PROPOSED DEVELOPMENT
ST. GEORGES HOTEL,
WESTCLIFF GARDENS,
BOURNEMOUTH,
DORSET, BH2 5HL

PROPOSED FLOOR PLANS
(3 OF 3)

PROPOSED FLOOR PLANS
(2 OF 3)

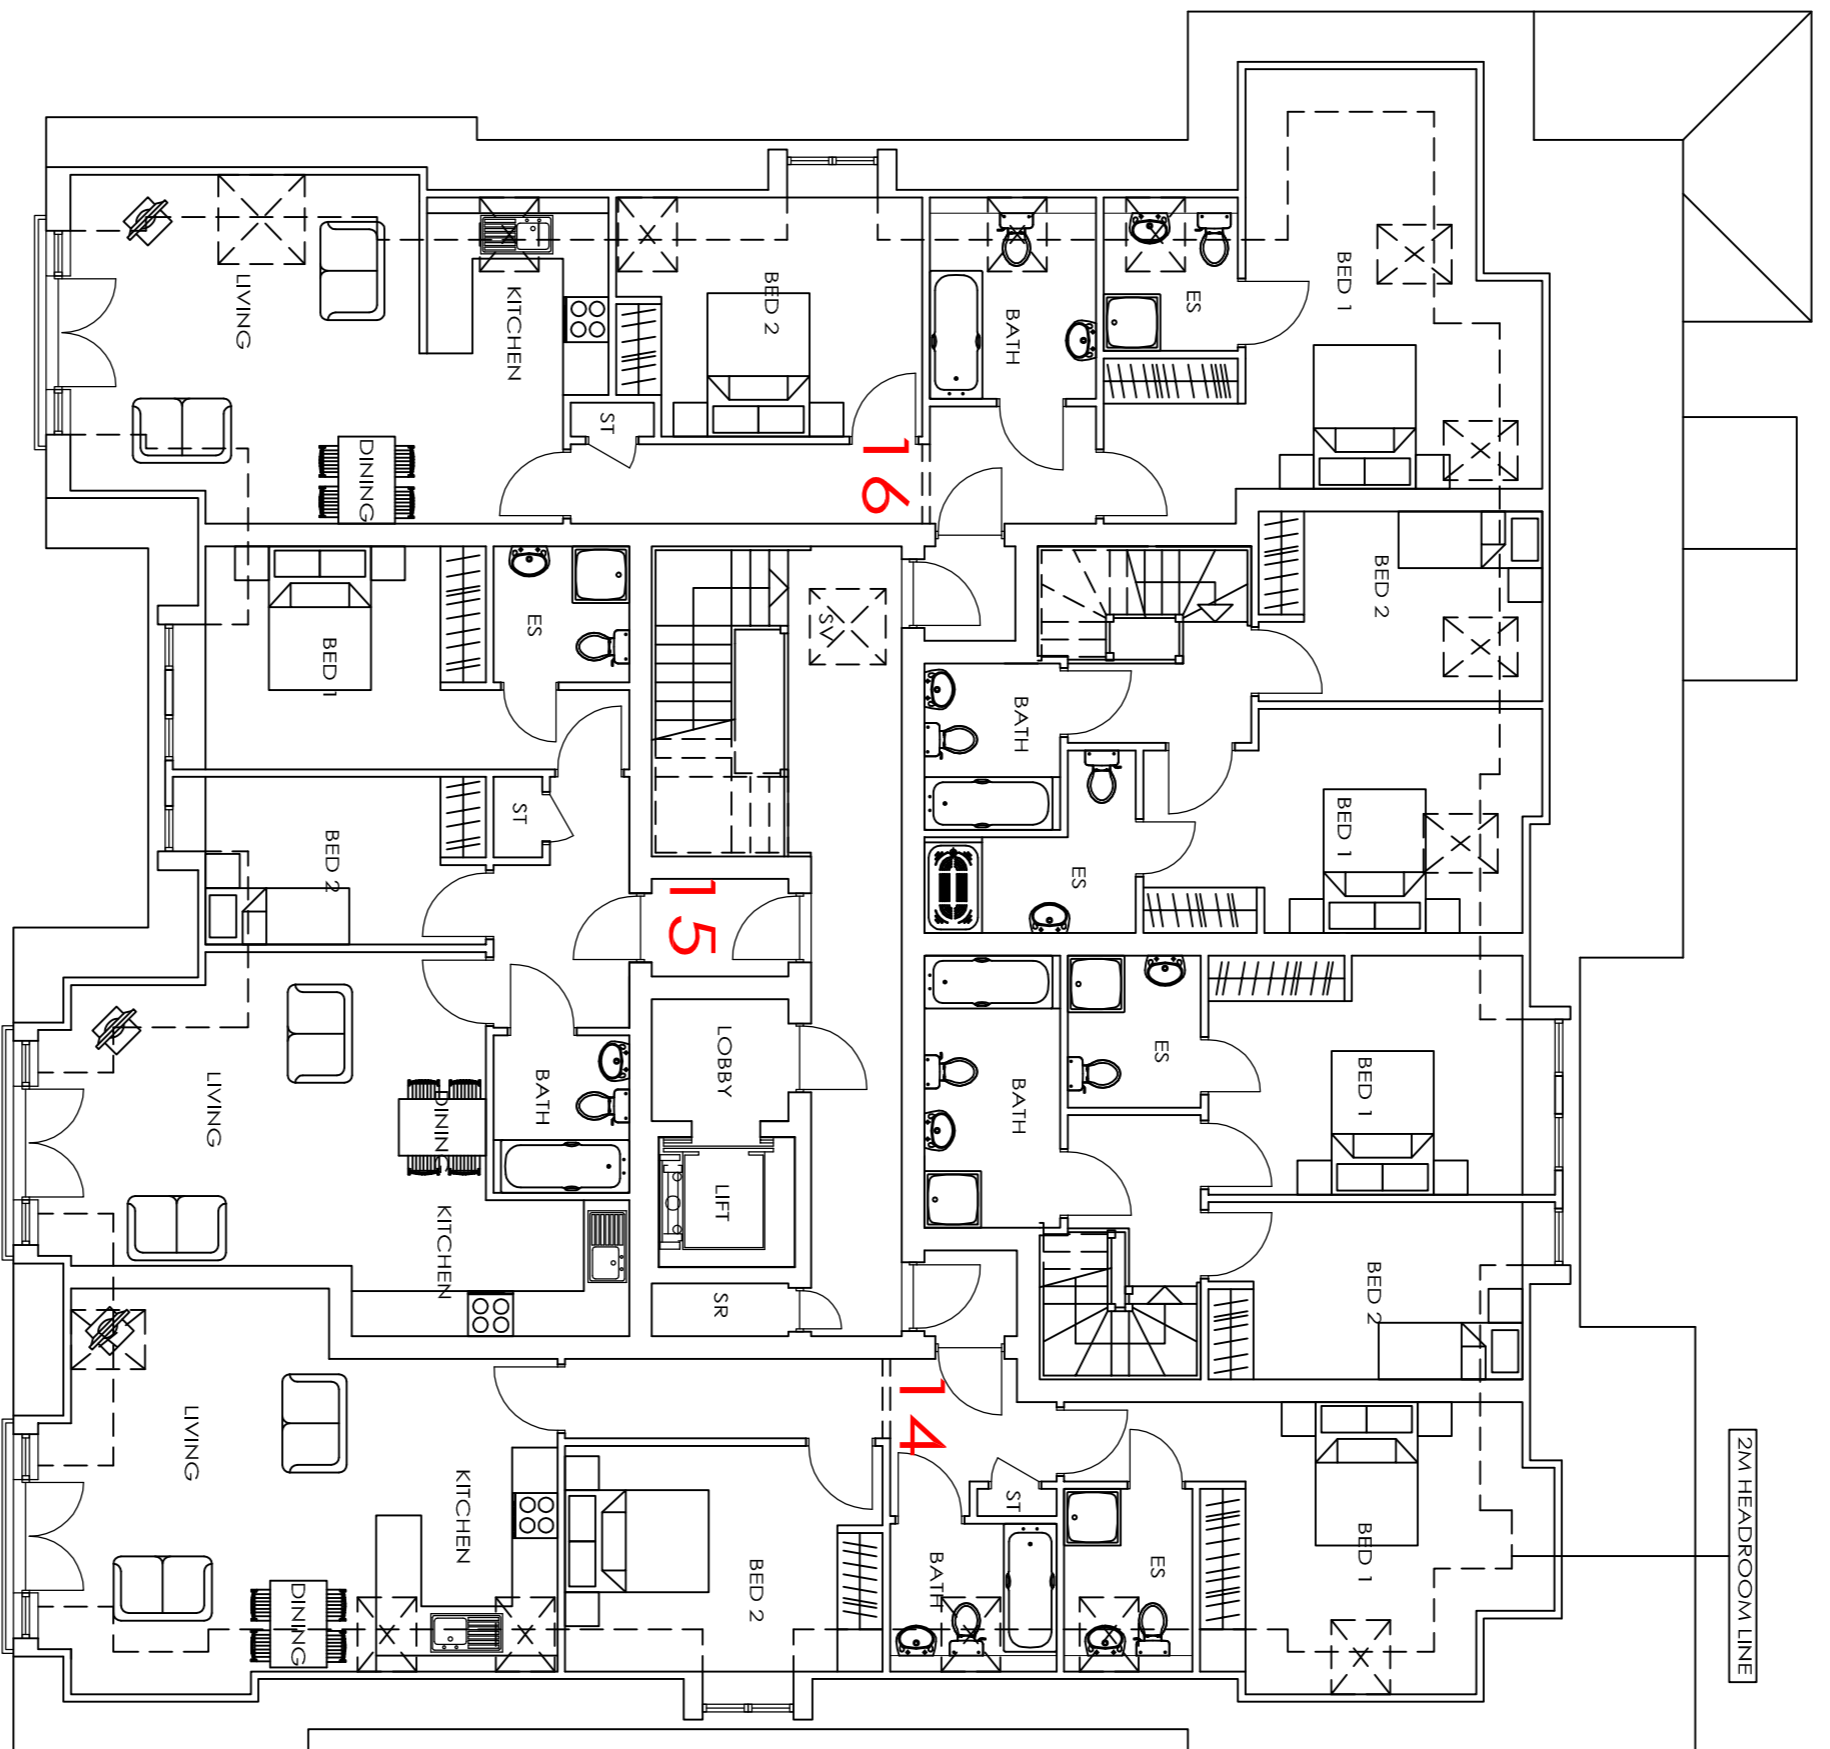
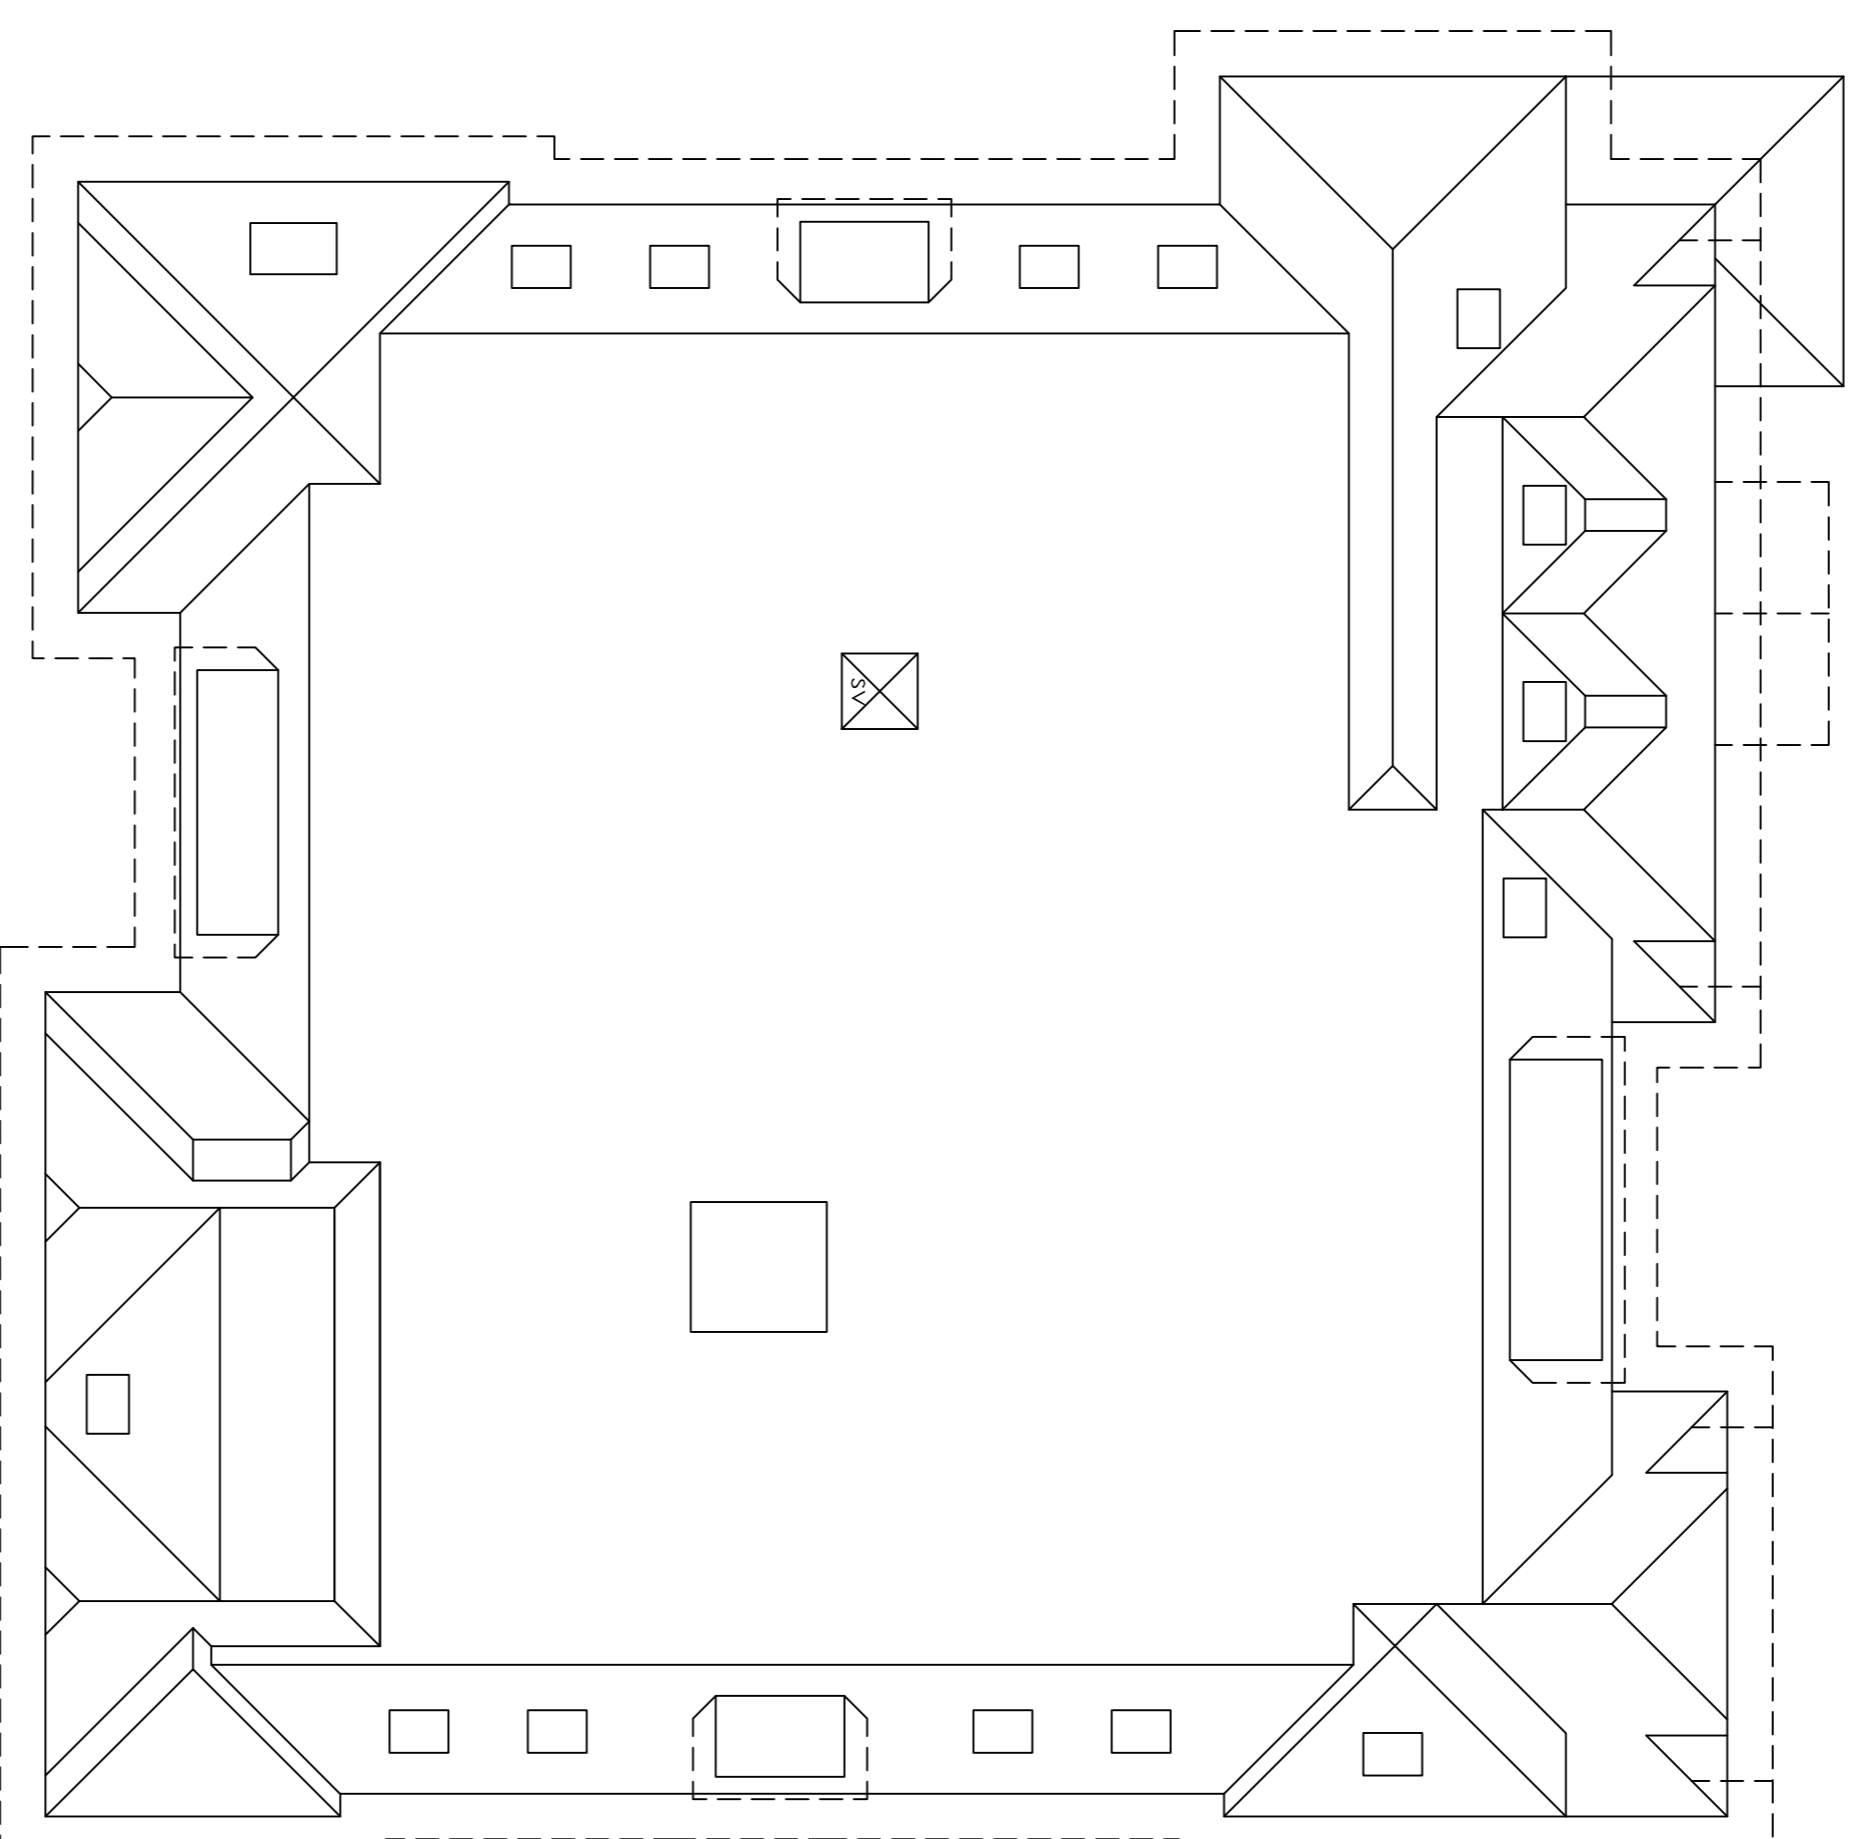
- A** PLANNERS COMMENTS: 25-10-11 LM
- MOVED MAIN ENTRANCE
 - FLAT 8 BALCONY REDUCED
 - AMENDMENT TO MATERIAL SCHEDULE
